# UNITED STATES PATENT AND TRADEMARK OFFICE

APPLICATION NO.	FILING DATE	FIRST NAMED INVENTOR	ATTORNEY DOCKET NO.	CONFIRMATION NO.
10/809,818	03/26/2004	Gary A. Carr	740883-187	7834
22204	7590	12/13/2005	EXAMINER	
NIXON PEABODY, LLP 401 9TH STREET, NW SUITE 900 WASHINGTON, DC 20004-2128			KAYES, SEAN PHILLIP	
			ART UNIT	PAPER NUMBER
			2841

## Office Action Summary

## **DETAILED ACTION**

I.

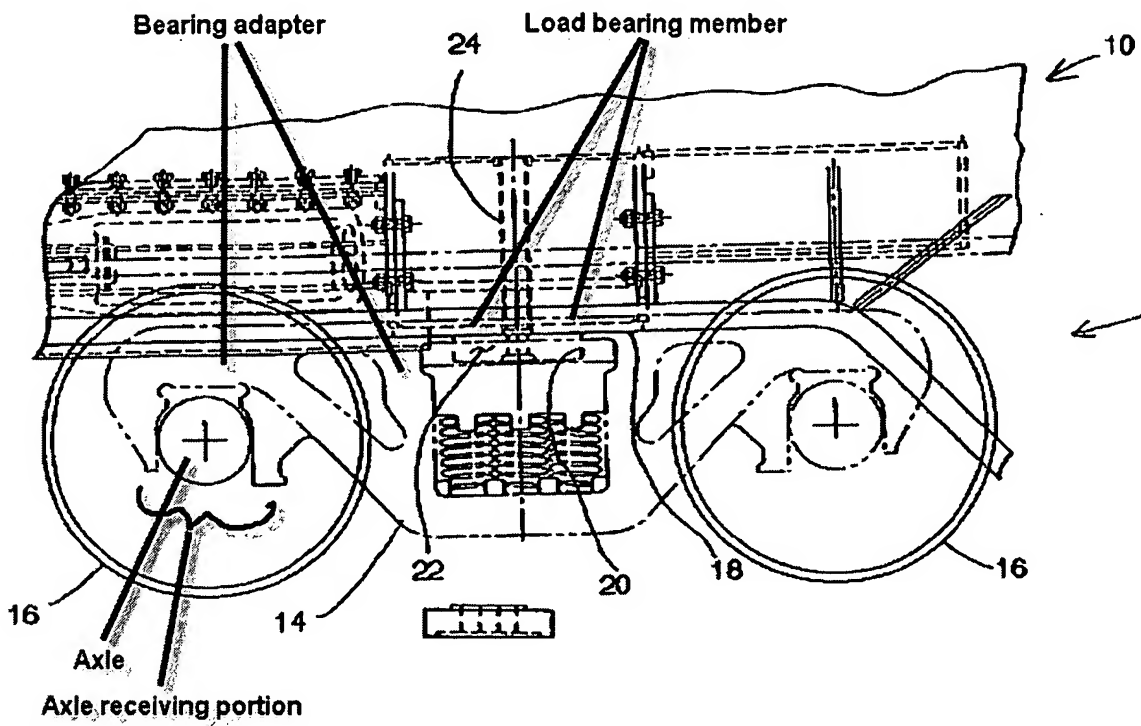
8. With respect to claim 1 Stimpson discloses A vertical load measurement device for measuring a load at least partially supported by an axle of a railcar comprising: a bearing adapter sized to be mounted between a load bearing member of the railcar and an axle bearing housing of the railcar (see picture I. below); at least one beam member having a first end and a second end (see picture II. below), at least one of said first end and second end being secured to said bearing adapter (the ends are secured by the of the weight loaded on the beam, column 2 lines 25-26), and a midsection extending between said first end and said second end which supports the load applied by the load bearing member of the railcar, said midsection being vertically spaced from said bearing adapter to allow deflection of said at least one beam member in response to the load applied by the load bearing member (column 4 lines 46-49); and a sensor secured to said beam member which measures said deflection of said beam member (see picture II. below.)

9. With respect to claim 2 Stimpson discloses a measurement device of claim 1 (see 102 rejection above,) wherein said bearing adapter includes an axle receiving portion (see picture I. above.)

10. With respect to claim 3 Stimpson discloses a measurement device of claim 2 (see 102 rejection above,) wherein said axle receiving portion is substantially semicircular in shape (see picture I, axle receiving portion of bearing adapter is substantially semi-circular.)

20. With respect to claim 22 Stimpson discloses the method of claim 19 (see 102 rejection above,) wherein said bearing adapter includes a substantially semicircular axle receiving portion (see picture I. provided above, bearing adapter is semicircular about the axle), said method further including the step of mounting said bearing adapter so that said axle bearing housing is received in said axle receiving portion (see picture I. provided above and column 4, lines 14-26.)

II.

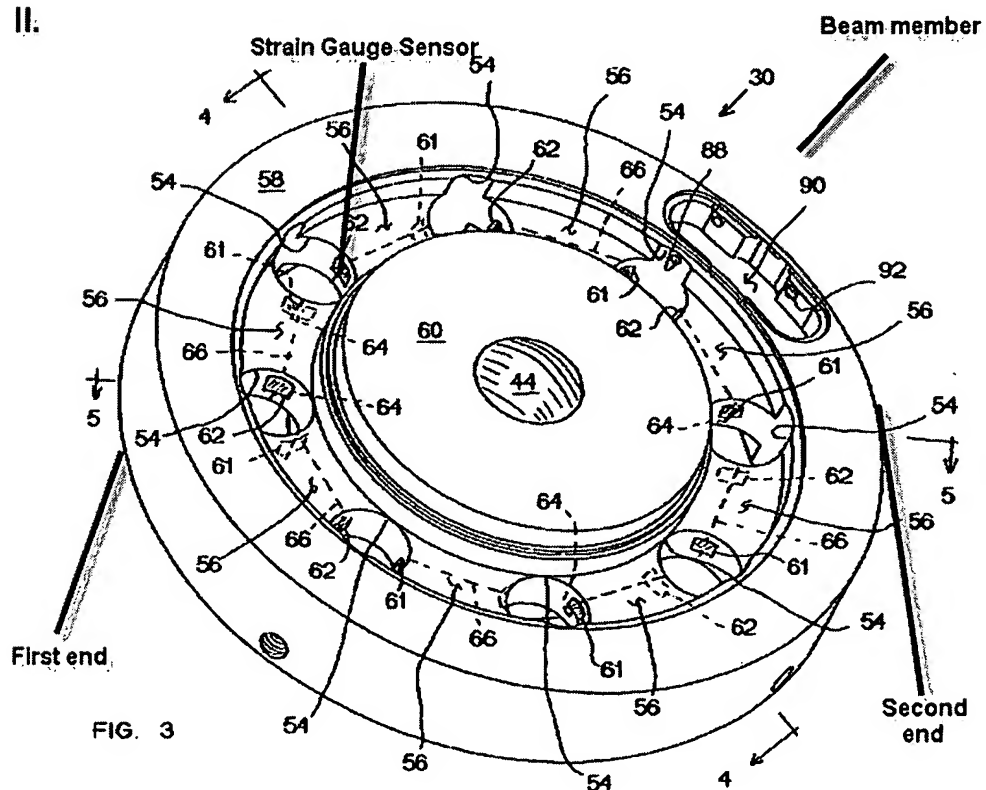
15. With respect to claim 9 Stimpson discloses a measurement device of claim 1 (see 102 rejection above,) wherein said sensor is at least one strain gauge (column 4 lines 52-55 and see picture II. above.)

III

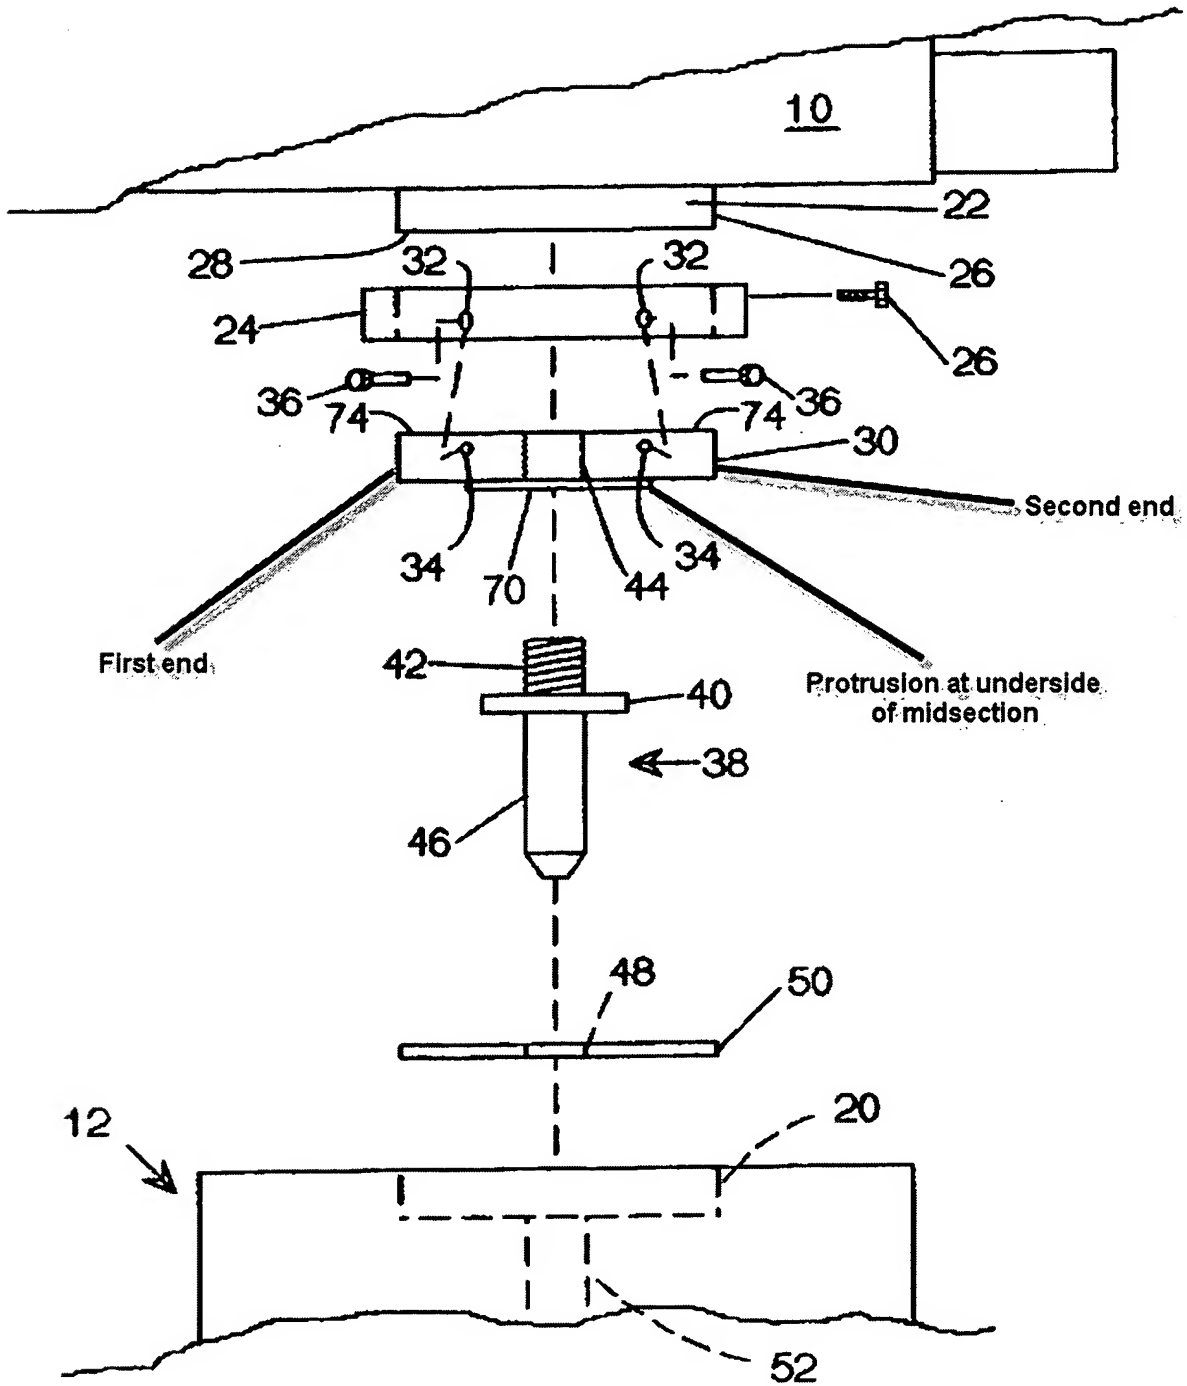
24. With respect to claim 7 Stimpson discloses a measurement device of claim 1(see 102 rejection above,) wherein said at least one beam member includes a protrusion at an underside of said midsection (see picture III. provided above.) Stimpson does not disclose that said protrusion limits deflection of said midsection of said beam member. In Stimpson's invention the protrusion on the end parts of the bar are what limit deflection.

At the time of the invention it would have been obvious to one skilled in the art to mount the protrusions at the external ends of Stimpson's bar to the bearing member and the center protrusion to the load bearing member as such a modification is a mere rearrangement of parts.
